Campaign No. 2021060014, July 2021

SUBJECT: **Model G-Class vehicles (463 platform)**
Model year 2019-2020

Replace Rear Door Lock – Code XZ8/XZ9 (MY19/MY20)

Figure 1

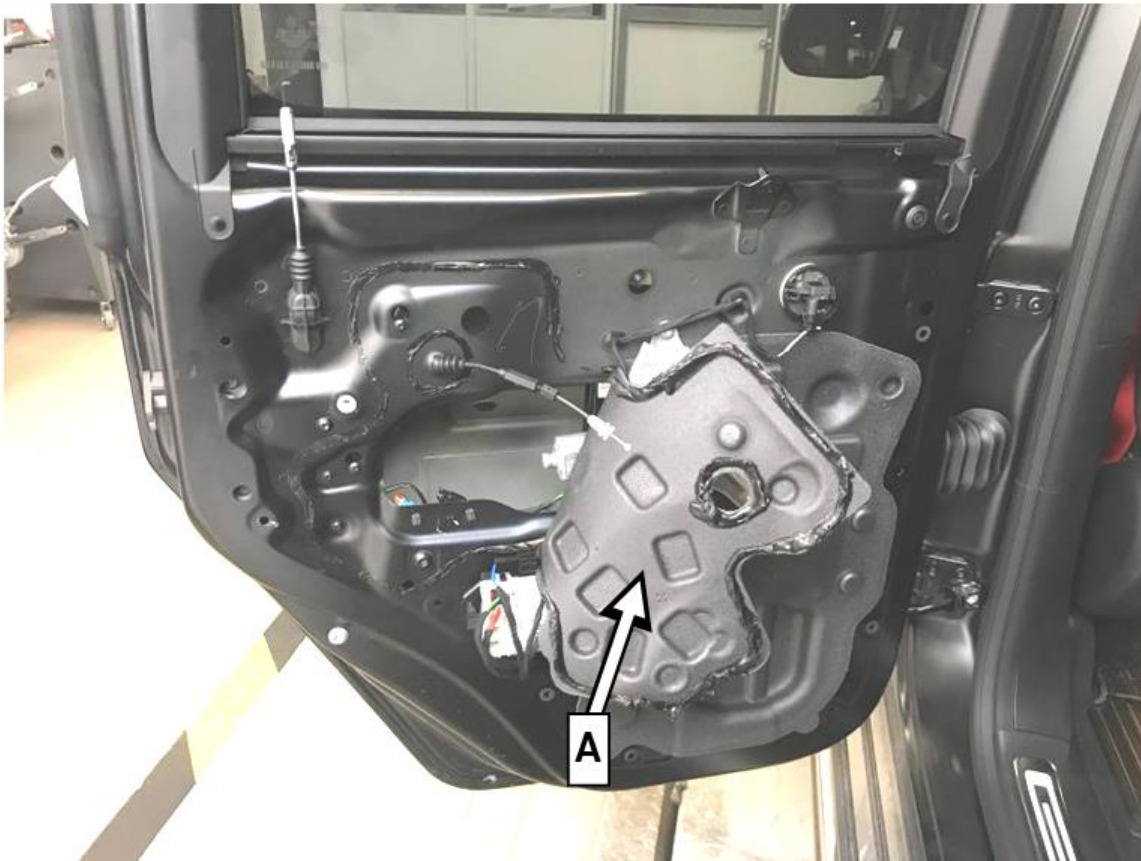
2. **Carefully** pull off door foam sheeting (**A, Figure 1**) from rear doors as shown.

i Door foam sheeting does not have to be completely removed and is reused.

Figure 3

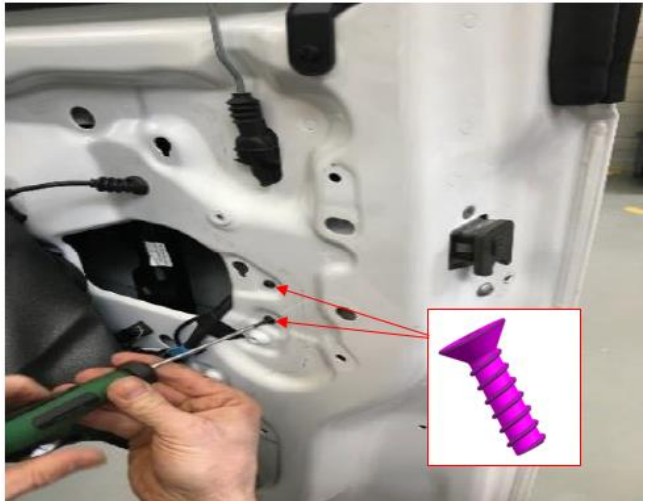
i The mounting screws on **CL actuators (Figure 3) MUST be replaced** and are included with the parts kit.
